Horse Heaven Wind Farm

Exclusion Mitigation

Sean Greene, Environmental Planner

Figure 3.6-2: Wildlife Movement Corridors within the Project Lease Boundary and Project Footprint

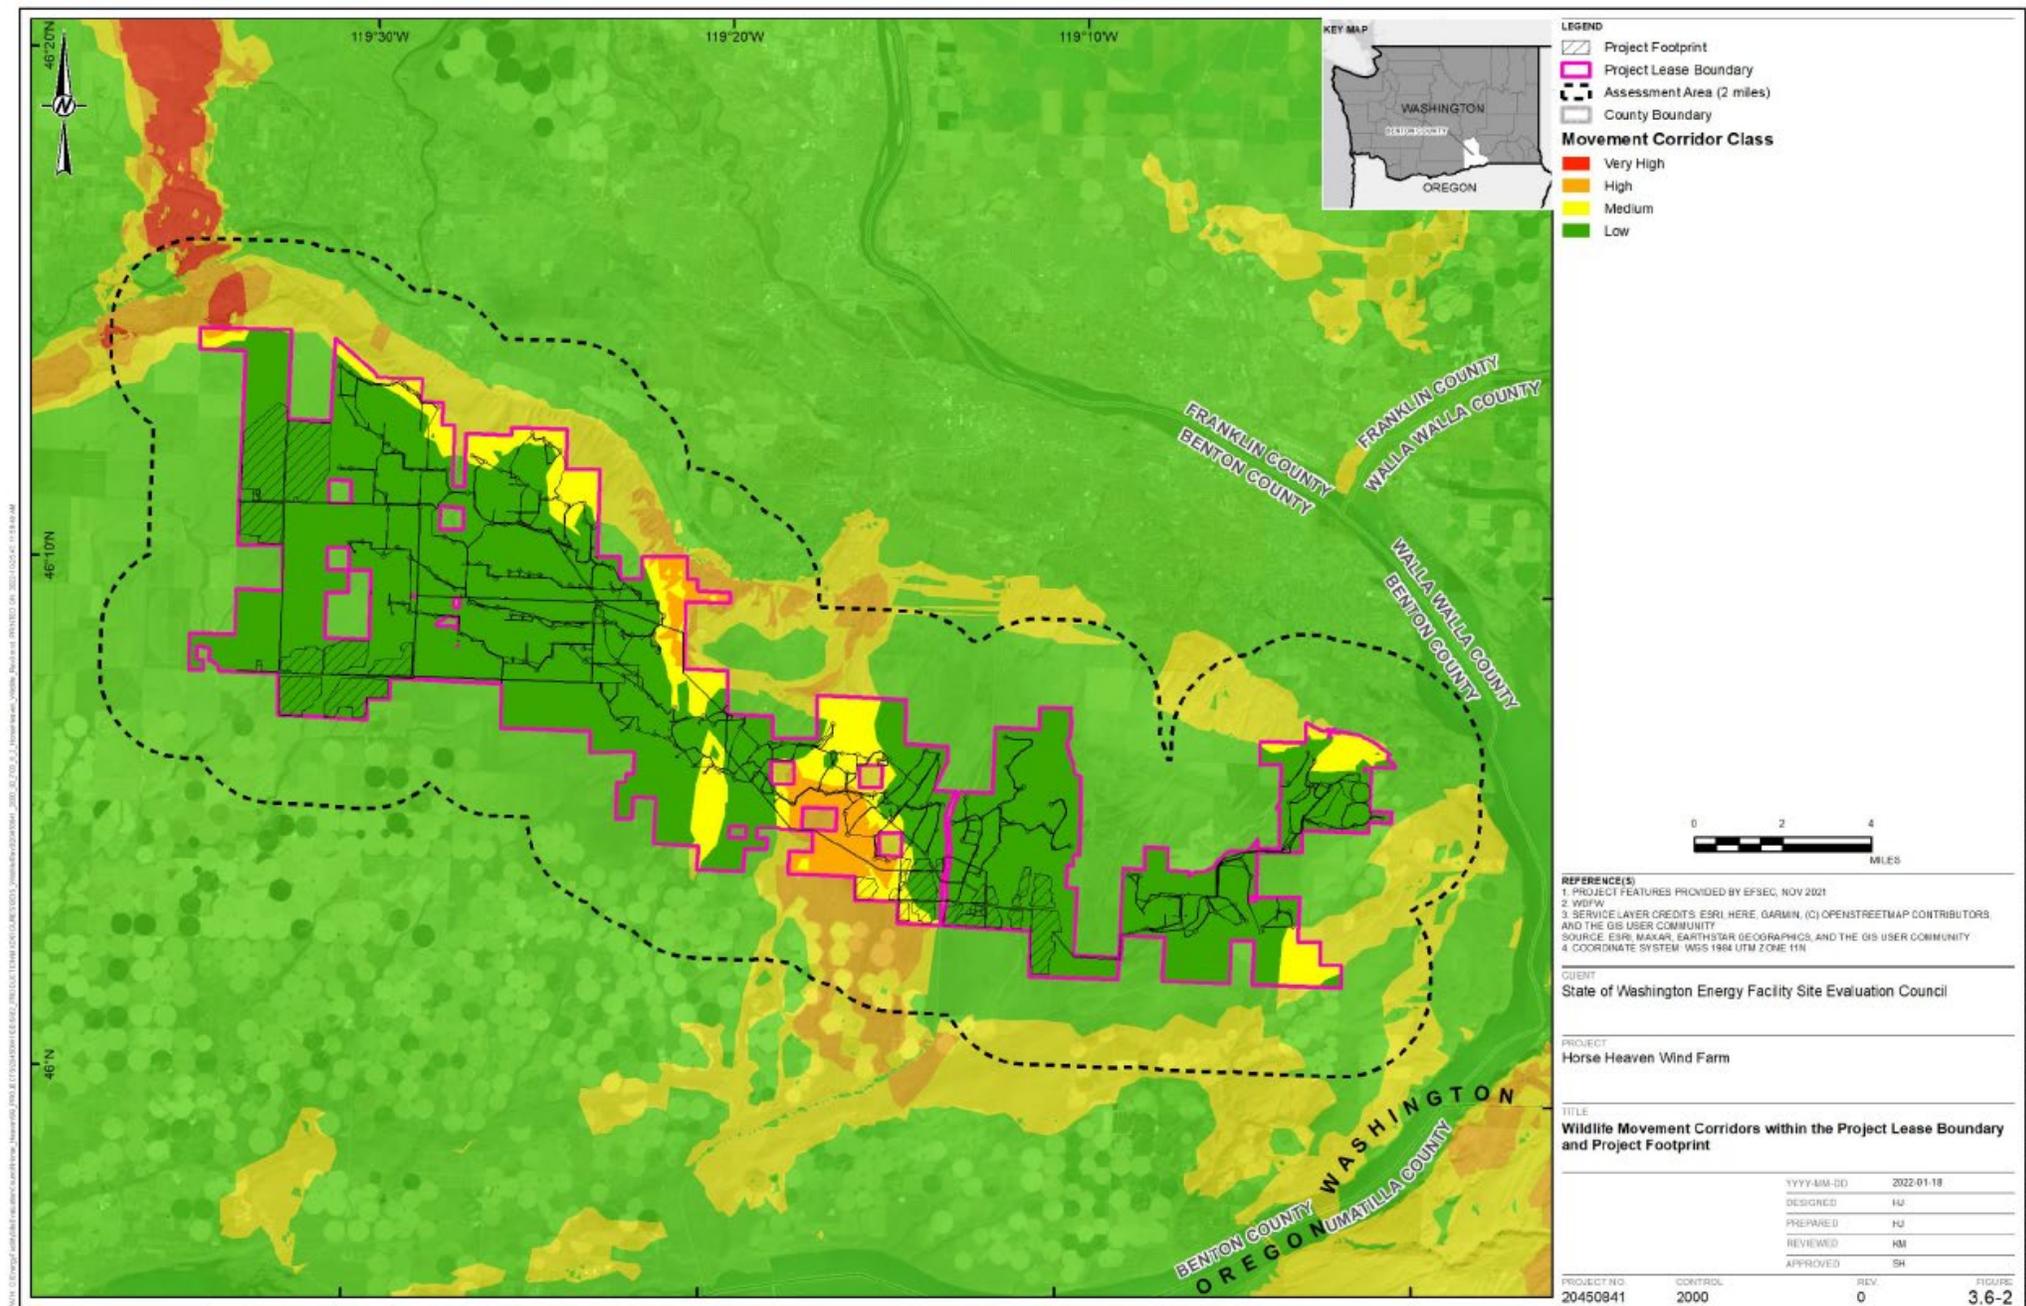
Hab-1: Movement Corridors

Current (As of 12/20/23)	WDFW Staff Feedback
<p>The Applicant would locate secondary Project components, including such as roads and powerlines, outside of movement corridors modeled in WWCWG (2013) as medium high to very high linkage and primary Project components, specifically turbines, solar arrays, and BESS, outside of movement corridors modeled as medium to very high linkage., to the extent feasible. The Applicant would provide rationale to EFSEC for siting any secondary components to be sited within medium-linkage movement corridors, and a Corridor Mitigation Plan would be required that describes:</p> <ul style="list-style-type: none">• Extent of direct and indirect habitat impact within the movement corridor• Proposed measures to be implemented to reduce potential impacts on movement corridors (e.g., habitat enhancements to promote continued use of corridors)• Proposed features (e.g., open-bottom culverts) to accommodate wildlife movement for linear Project components (e.g., roads, powerlines)• Proposed restoration in movement corridors following Project decommissioning• Performance standards to assess the effectiveness of mitigation measures and restoration• Methods to monitor and measure performance standards <p>The Corridor Mitigation Plan would be developed in consultation with the PTAG and reviewed and approved by EFSEC prior to implementation. Results of corridor monitoring would be reviewed annually with the TAC to evaluate the effectiveness and apply additional measures if necessary. Data would be provided to EFSEC with additional mitigation measures for review and approval prior to implementation.</p>	<ul style="list-style-type: none">• EFSEC staff asked WDFW staff how “primary Project components” should be defined for the purposes of mitigation.<ul style="list-style-type: none">• <i>WDFW staff believe that “primary Project components” should be defined as turbines, solar arrays, and BESS, consistent with the current version of Hab-1.</i>• EFSEC staff asked WDFW staff whether primary Project components should be excluded from medium to very high linkage corridors or high to very high linkage corridors.<ul style="list-style-type: none">• <i>WDFW staff believe that primary Project components should not be sited in medium to very high linkage corridors, consistent with the current version of Hab-1.</i>• EFSEC staff asked WDFW staff whether secondary Project components should be excluded from high to very high linkage corridors or allowed in corridors with a Corridor Mitigation Plan.<ul style="list-style-type: none">• <i>WDFW staff believe that primary Project components should not be sited in high to very high linkage corridors, but could be sited in medium linkage corridors with a Corridor Mitigation Plan, consistent with the current version of Hab-1.</i>

Hab-1: Movement Corridors – Council Questions

- Should primary Project components (turbines, solar arrays, and BESS) be:
 - A. Allowed within corridors when combined with a Corridor Mitigation Plan (FEIS Version);
 - B. Excluded from high to very high linkage corridors; or
 - C. Excluded from medium to very high linkage corridors (Current Version)?

Hab-1: Movement Corridors – Council Questions

- Should secondary Project components (i.e., roads, substations, transmission lines, etc.) be:
 - A. Allowed within corridors when combined with a Corridor Mitigation Plan (FEIS Version);
 - B. Excluded from high to very high linkage corridors (Current Version); or
 - C. Excluded from medium to very high linkage corridors?

TITLE
TURBINE LAYOUT OPTION 1
REMOVAL OF TURBINES - FOR COUNCIL REVIEW CONSIDERATION NO. 1

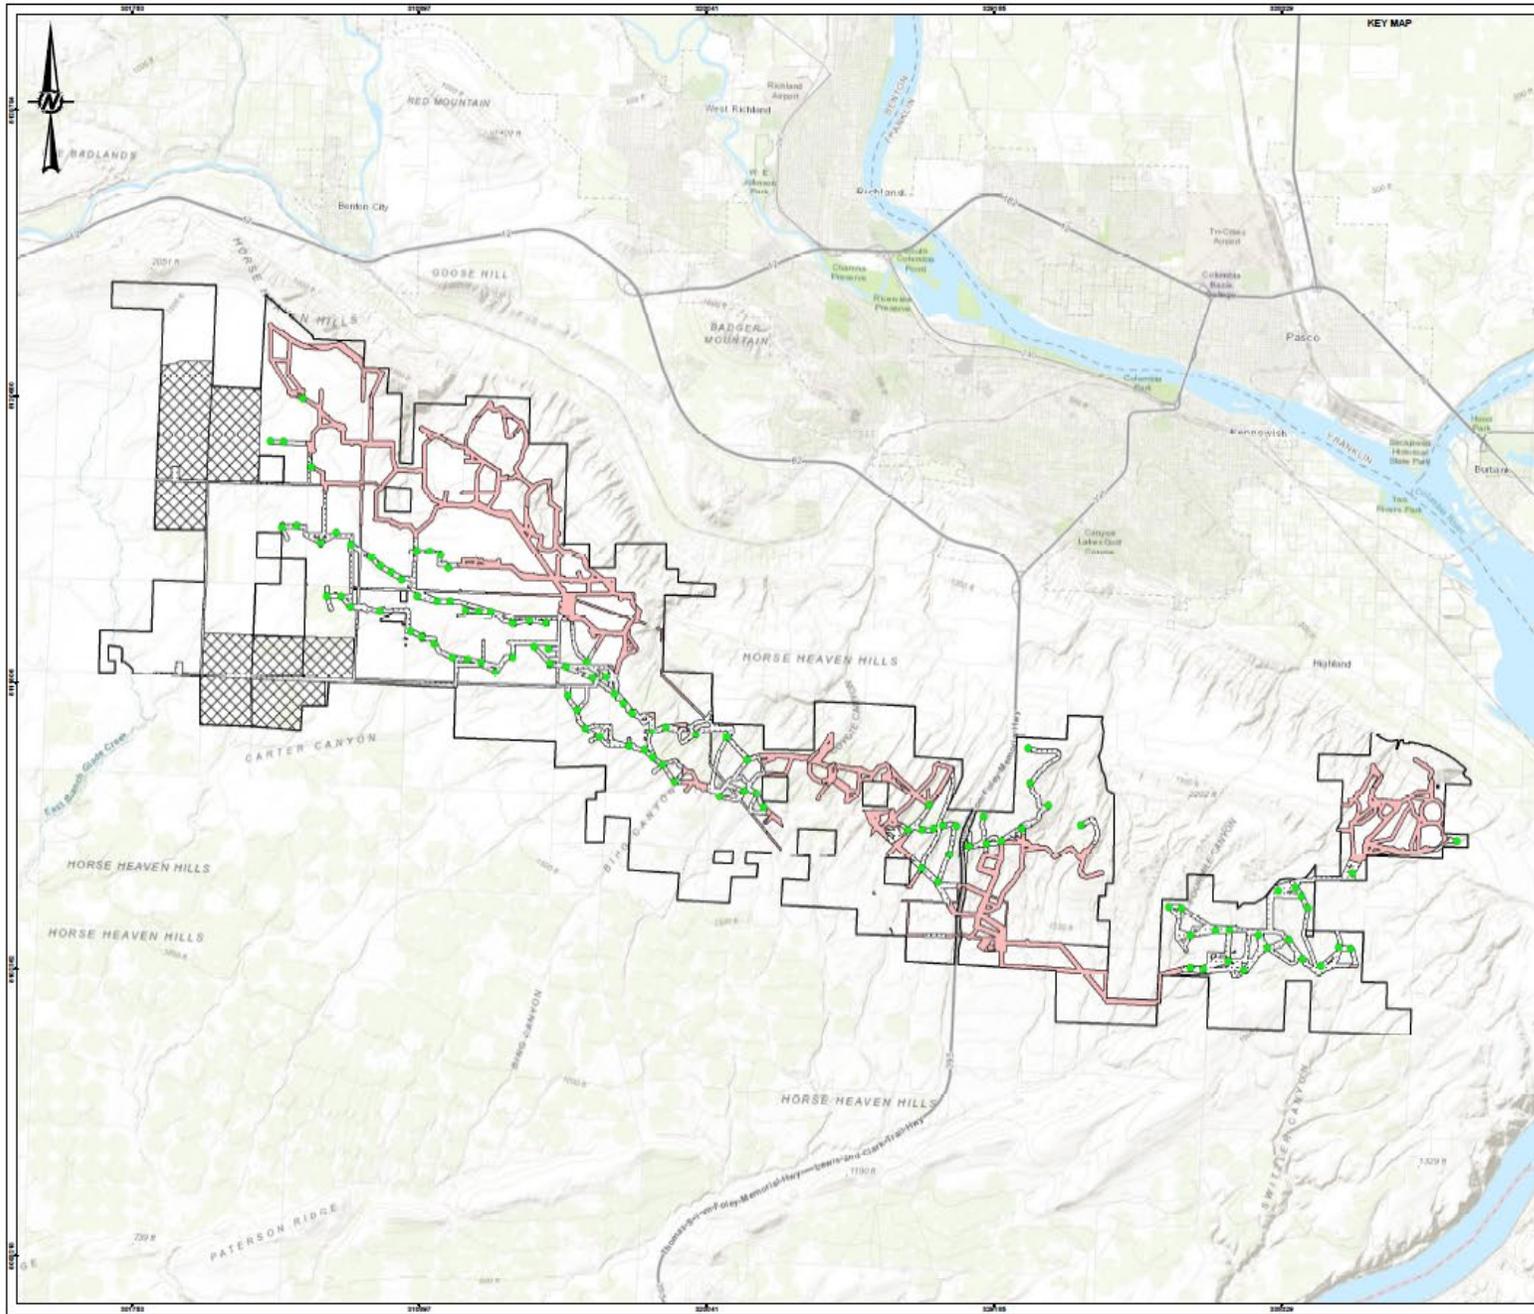
Spec-5: Ferruginous Hawk

The Applicant would ~~avoid not site siting~~ primary Project components, ~~specifically turbines, solar arrays, and BESS~~, within core habitat in ferruginous hawk territories, defined as the ~~habitat area~~ within a 2-mile radius surrounding ferruginous hawk nests documented in PHS data and in Horse Heaven Wind Farm, LLC (2022). Siting of ~~features-secondary Project components, such as transmission lines and roads~~, within 2 miles of a known ferruginous hawk nest may be considered if the Applicant is able to demonstrate that the nest site and foraging habitat is no longer available to the species and that compensation habitat, as described below, would provide a net gain in ferruginous hawk habitat. ...

- EFSEC staff requested WDFW staff feedback whether there were any Project components that would not impact ferruginous hawks if sited within 2 miles of a documented nest.
 - *WDFW staff believe that any Project components sited within a 2-mile radius of a documented ferruginous hawk nesting territory would result in adverse impacts to the species.*

Spec-5: Ferruginous Hawk – Council Questions

- Should primary Project components (turbines, solar arrays, and BESS) be:
 - A. Allowed within 2 miles of a documented ferruginous hawk only when the Applicant can demonstrate that the nest is inactive, no viable foraging habitat is present, and produces a mitigation and management plan (FEIS Version);
 - B. Excluded from all areas within 0.5 miles (existing WDFW seasonal buffer) of a documented ferruginous hawk nest, but allowed from 0.5-2 miles of a documented ferruginous hawk only when the Applicant can demonstrate that the nest is inactive, no viable foraging habitat is present, and produces a mitigation and management plan; or
 - C. Excluded from all areas within 2 miles of a documented ferruginous hawk nest (Current Version)?

Spec-5: Ferruginous Hawk – Council Questions

- Should secondary Project components (i.e., roads, substations, transmission lines, etc.) be:
 - A. Allowed within 2 miles of a documented ferruginous hawk only when the Applicant can demonstrate that the nest is inactive, no viable foraging habitat is present, and produces a mitigation and management plan (FEIS/Current Version);
 - B. Excluded from all areas within 0.5 miles (existing WDFW seasonal buffer) of a documented ferruginous hawk nest, but allowed from 0.5-2 miles of a documented ferruginous hawk only when the Applicant can demonstrate that the nest is inactive, no viable foraging habitat is present, and produces a mitigation and management plan; or
 - C. Excluded from all areas within 2 miles of a documented ferruginous hawk nest?

TITLE
 TURBINE LAYOUT OPTION 1
 REMOVAL OF TURBINES - FOR COUNCIL REVIEW CONSIDERATION NO. 3

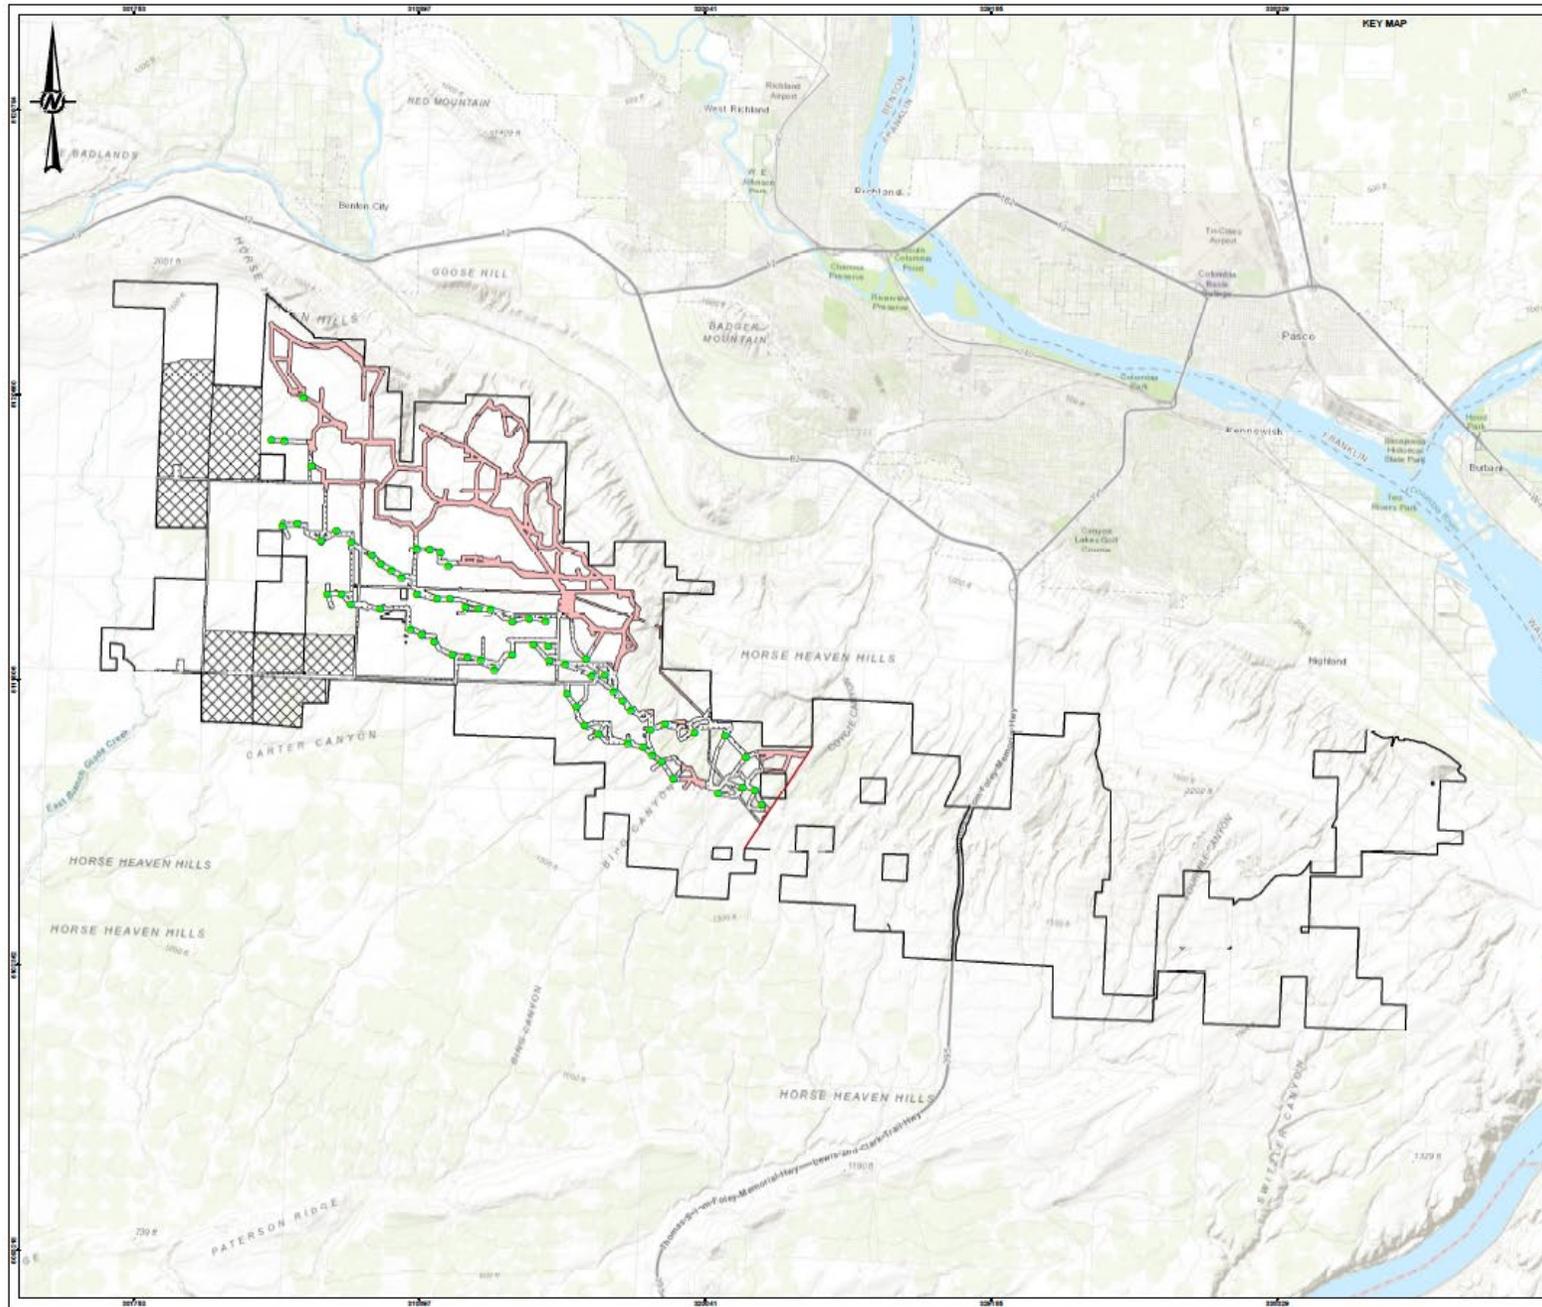
CR-3: TCP Minimization and Avoidance

Original	Proposed (As of 12/20/23)
N/A	To reduce Project impacts to identified TCPs, the Applicant would not locate any Project components east of the boundaries of Straub Canyon, as defined by EFSEC.

CR-3: TCP Minimization and Avoidance – Council Question

- Should all Project components be:
 - A. Allowed east of Straub Canyon (FEIS Version); or
 - B. Excluded from all areas east of Straub Canyon (Proposed Version)?
